APPEAL SUMMARY

Appeal ID: 15734

Project Address: 55 NE Grand Ave

LUR or Permit Application No.: 16-112454-REV-02-MT

ISSUED FOR CONSTRUCTION
JULY 28, 2016
A2.10A
FLOOR PLAN
BASEMENT
SECTOR 'A'

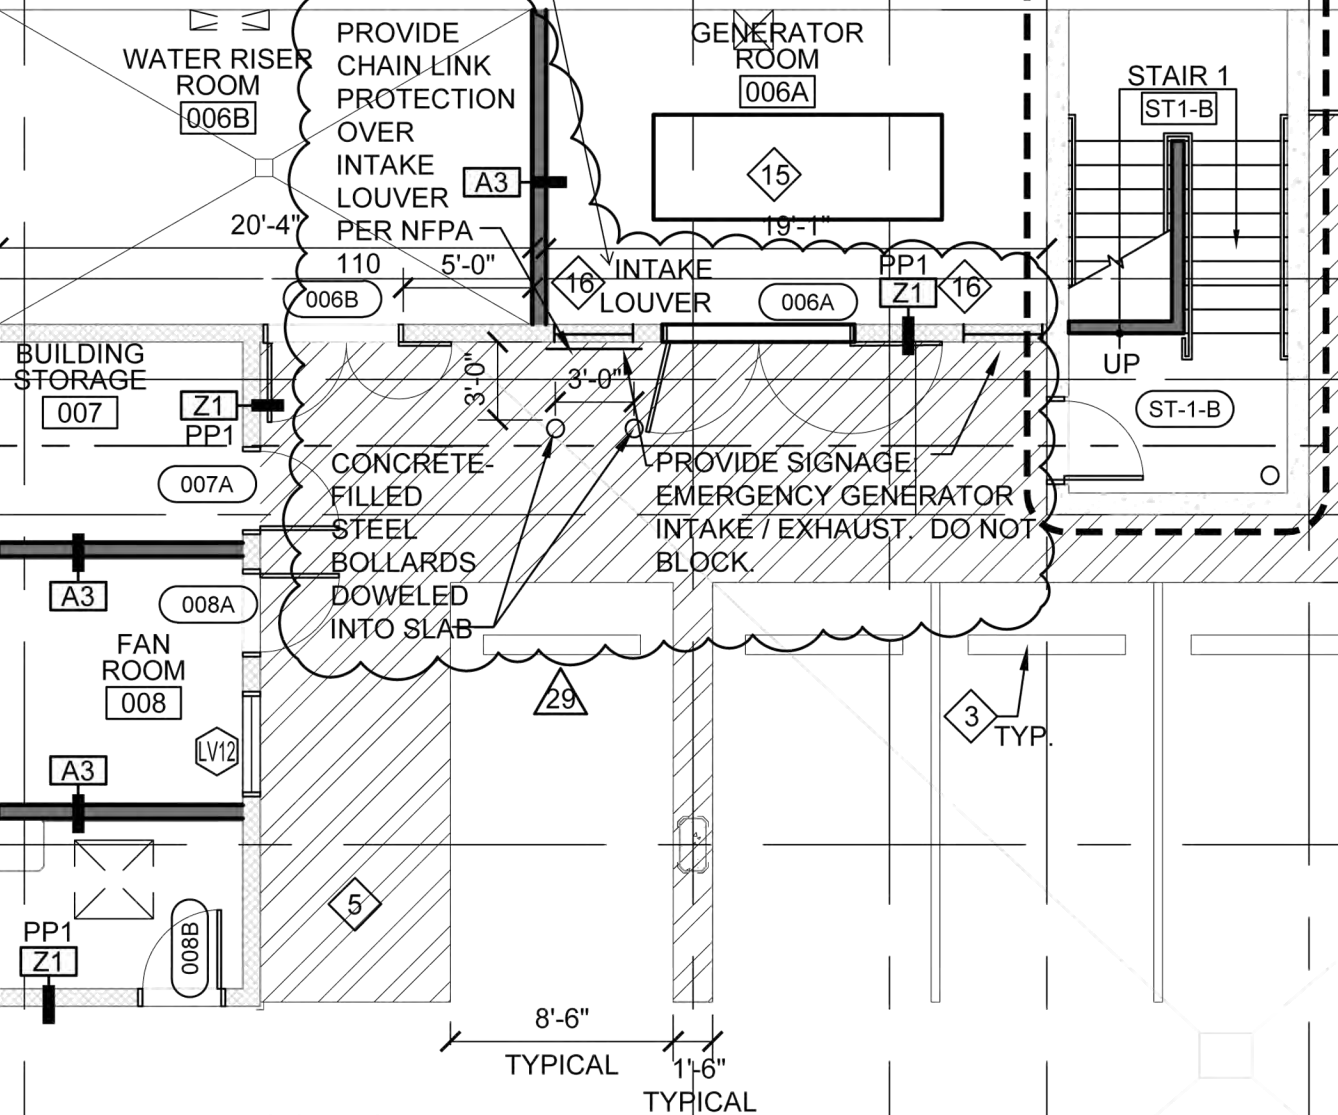
Further, sprinkler heads will be provided on either side of intake exhaust louver at the generator room as requested on the mechanical checksheet, as well as bollards and chain link, and signage stating not to block the louver.

1b. Sprinkler protection in lieu of fire damper at intake opening: Granted as proposed.

Enlarged plan
from A2.10A

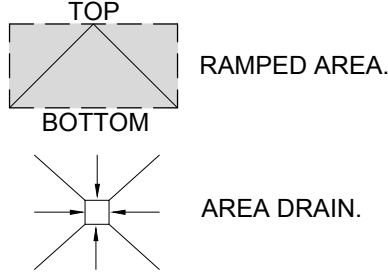
PROVIDE SPRINKLER
HEADS ON BOTH
SIDES OF INTAKE
LOUVER

FREE AREA GUIDE

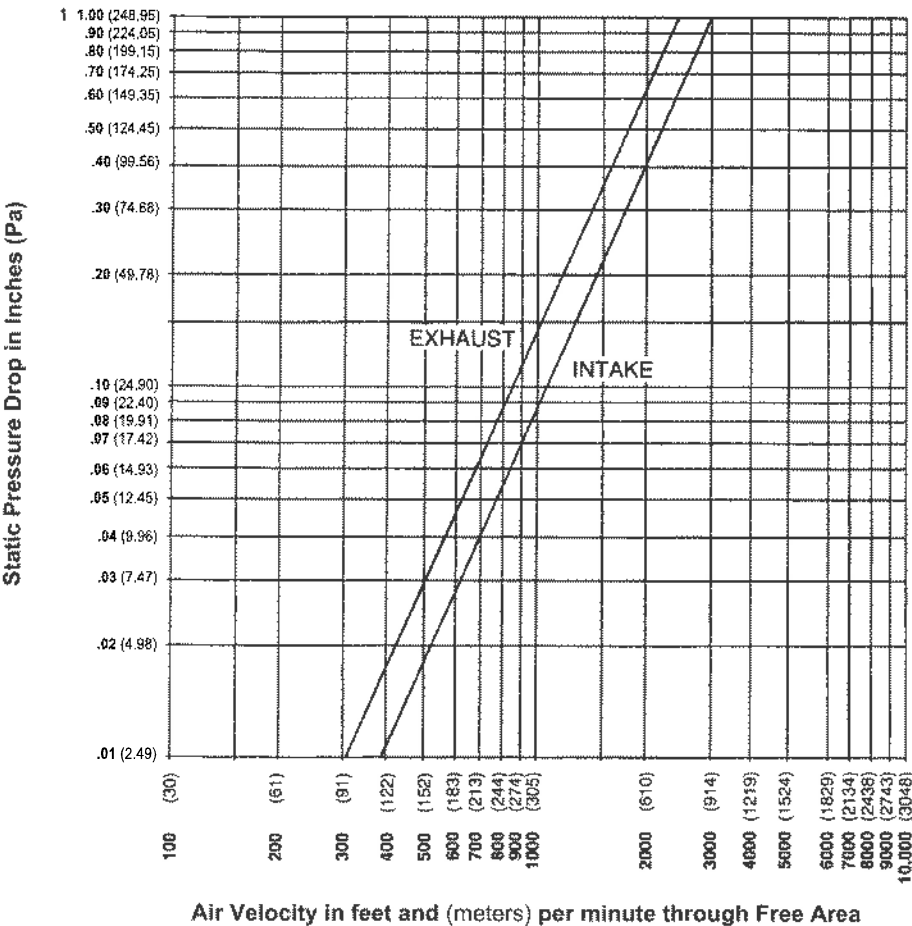
Free area for louvers over the garage door is 30.60 sf. (the garage door is glass) See attached chart from the louver manufacturer.

There are (3) 80" x 36.6" louvers over the garage door. The garage door is glass. Free area per louver = 10.20 sf x 3 louvers = 30.60 sf of free area total

1 POWER & SIGNAL PLAN - BASEMENT SECTOR 'A'
E2.10A SCALE: 1/8"=1'-0"

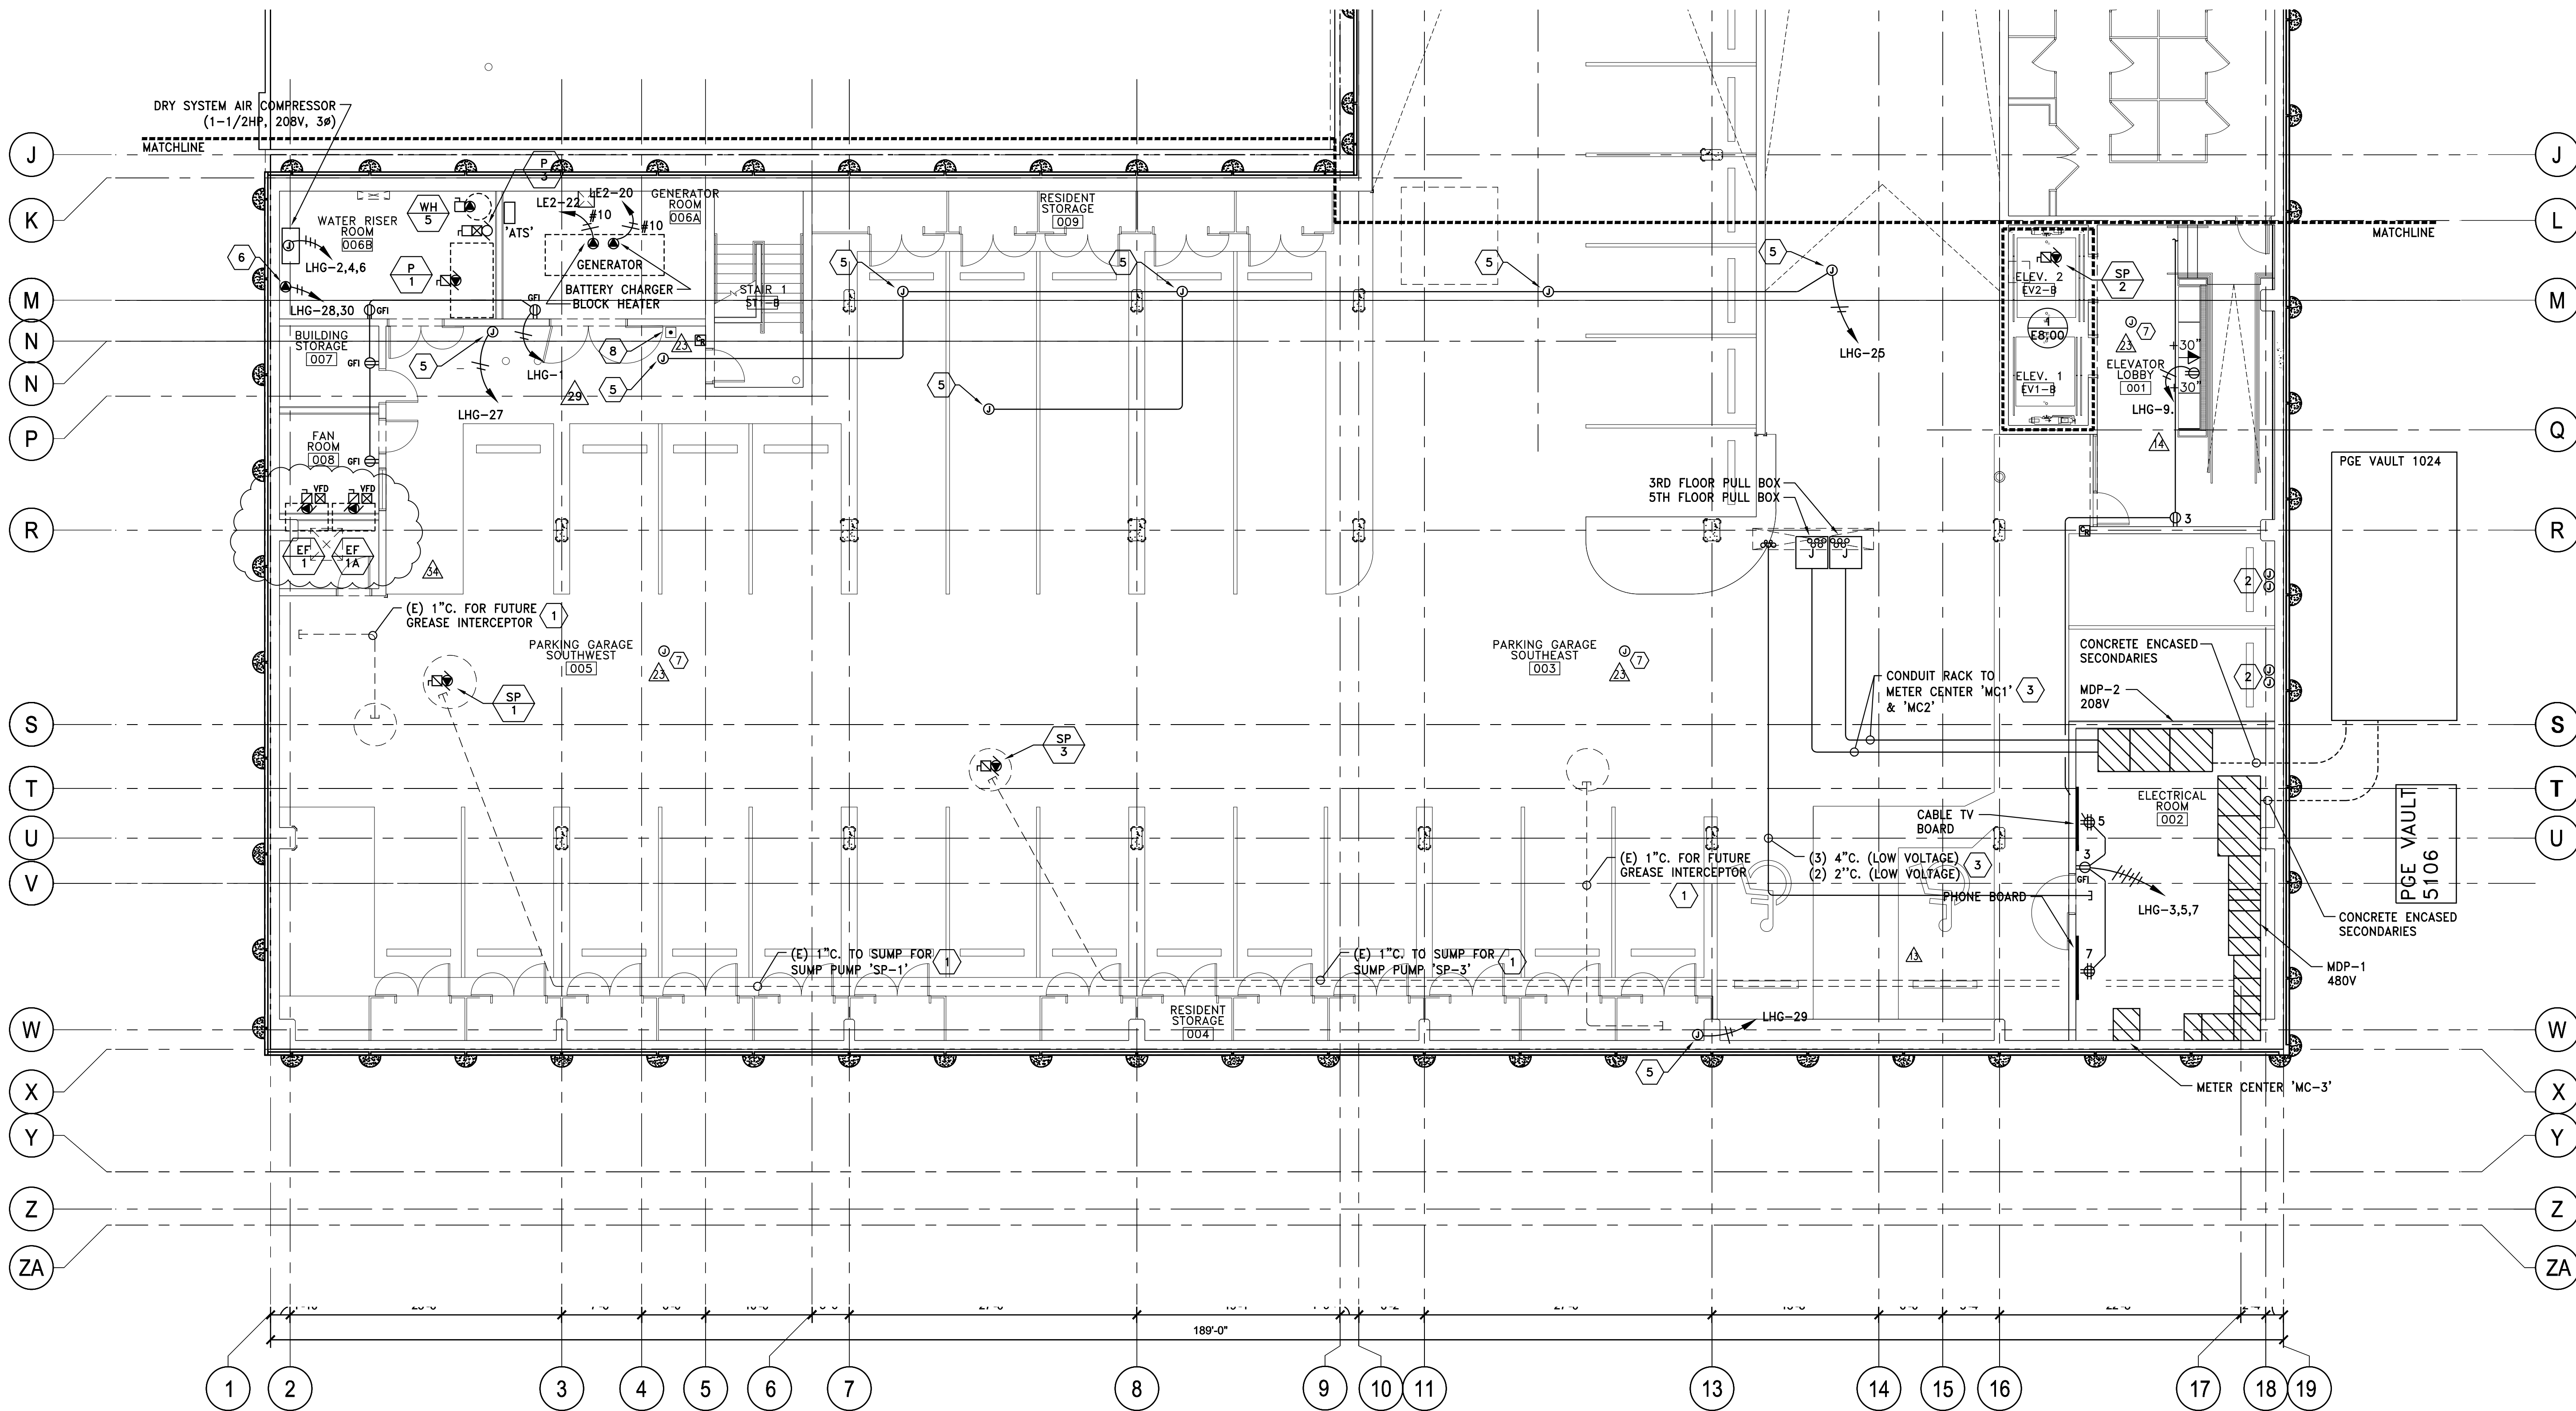
As requested, an additional fan has been added to the fan room for redundancy for garage air exhaust. Both fans are on an emergency circuit. Revised electrical drawings are attached.

M2.10A
BASEMENT
SECTOR 'A'
HVAC

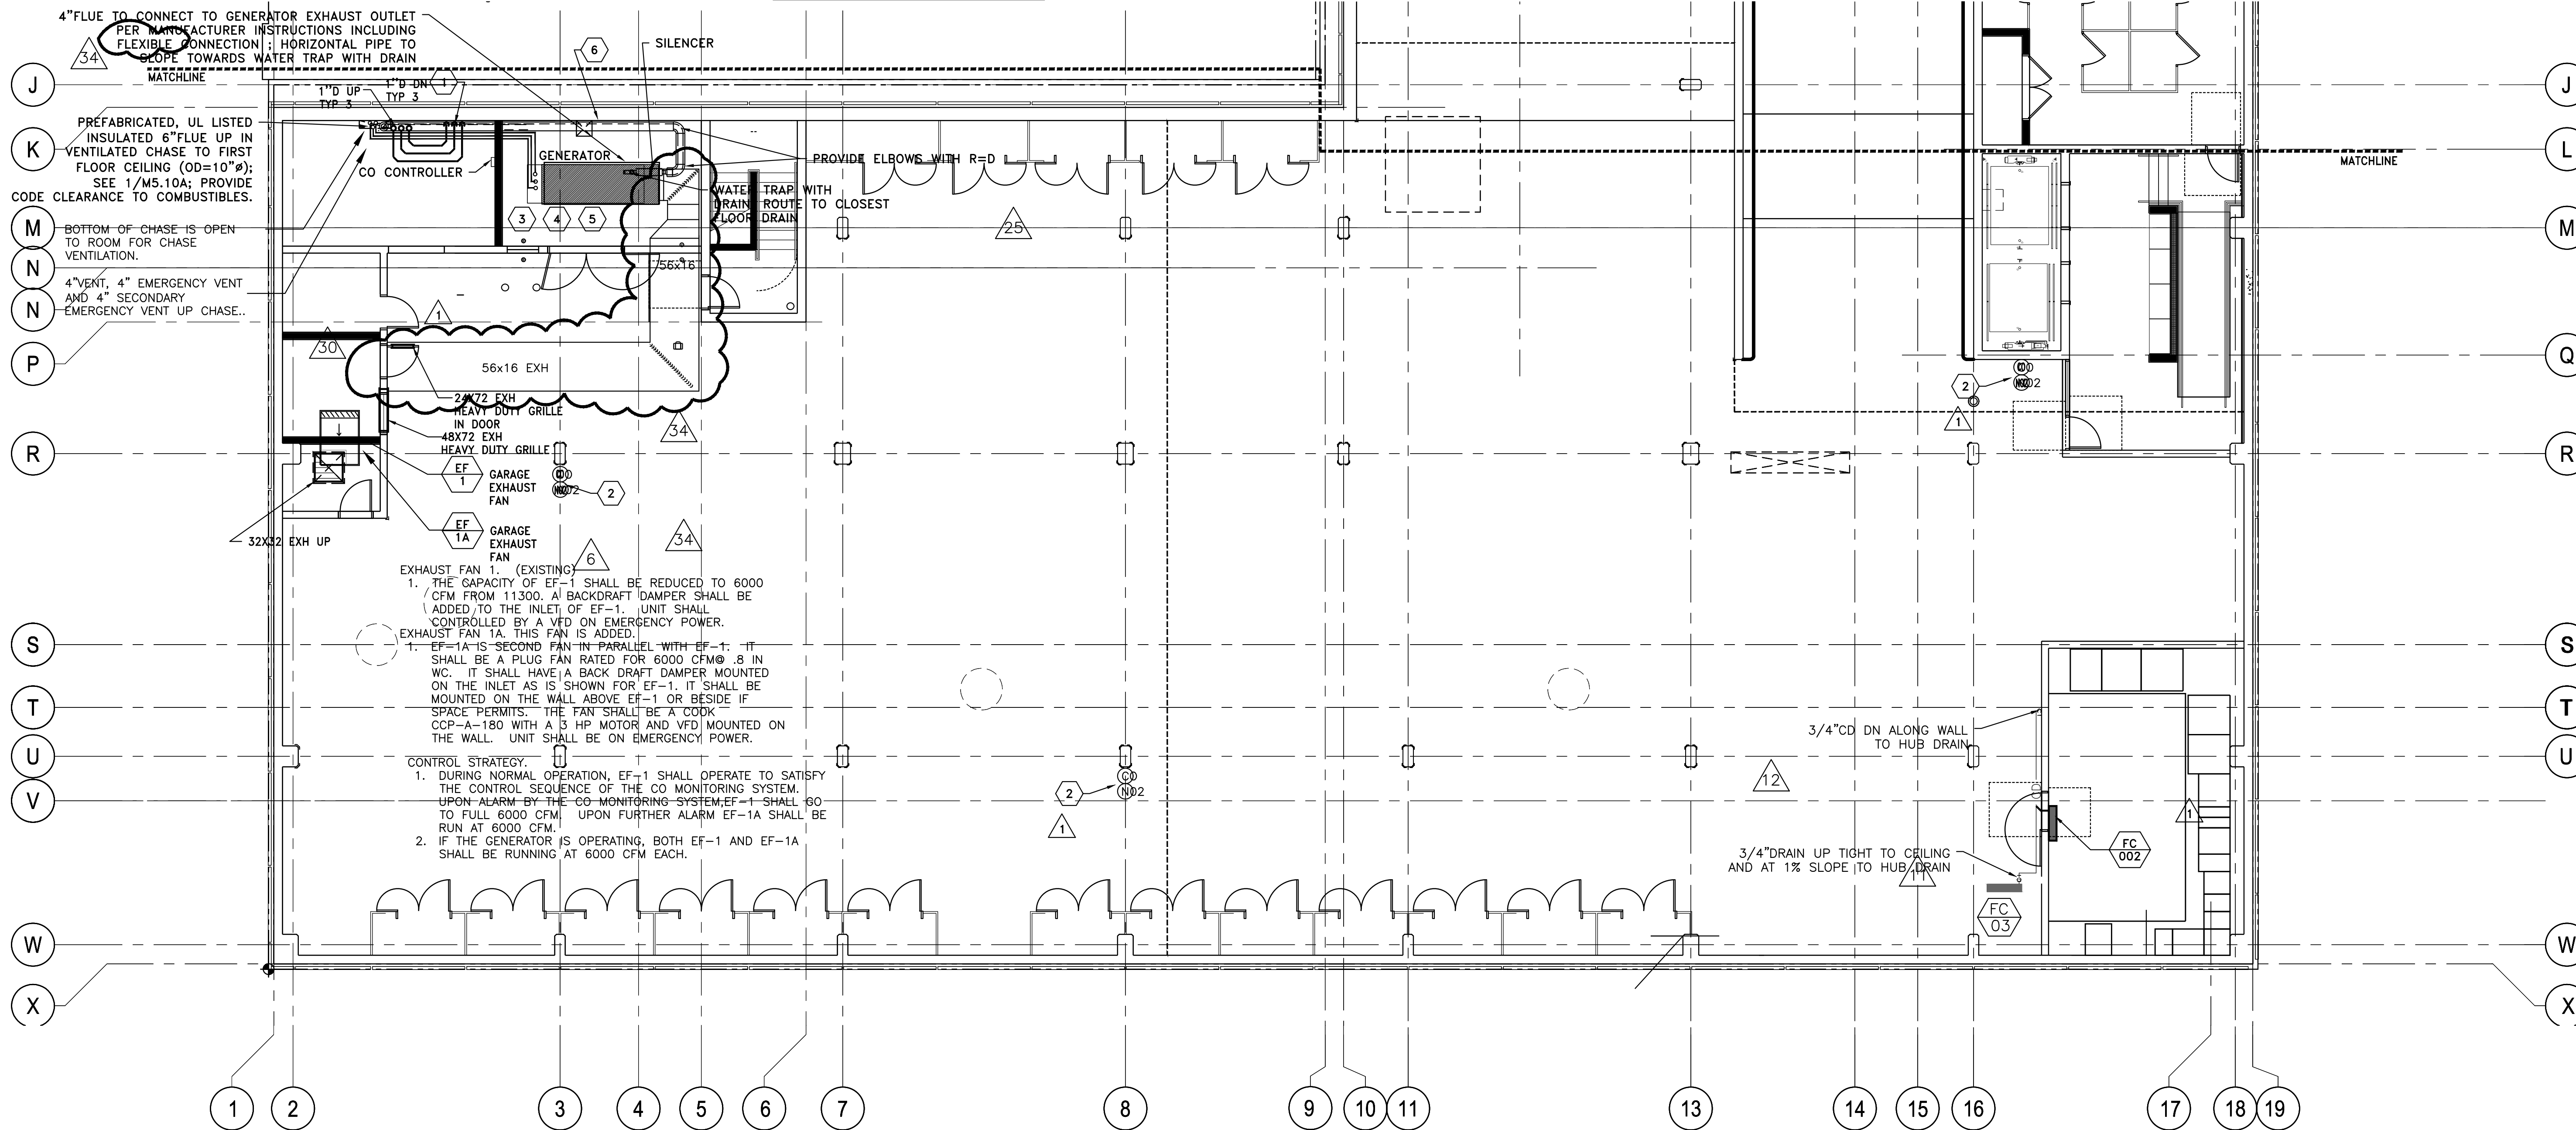
Proposed Design Per a meeting with Thomas Ng and Joe Thornton on Wednesday 8/16, exhaust air from the generator room will be ducted directly to the fan room (2 hour walls and 4 hour slab above. Slab on grade below) where it will then be carried directly to the exterior with a 2 hour rated shaft and plenum. See attached enlarged plans and wall types for reference. This will keep heater air from recirculating back into the generator room via the air intake louver.

There is a louver at the exterior of the building at the first floor already for the garage exhaust air. The generator room exhaust air will be directed to the same louver. See revised mechanical drawings.

Minimum headroom clearance of 7' inside the garage will be maintained beneath the duct running from the generator room to the fan room.

1a. Intake air from parking garage to serve emergency generator with exhaust ducted through fan room to exhaust louver: Granted provided minimum ventilation rate per OMSC 404.2 is confirmed at time of mechanical permit plan review.
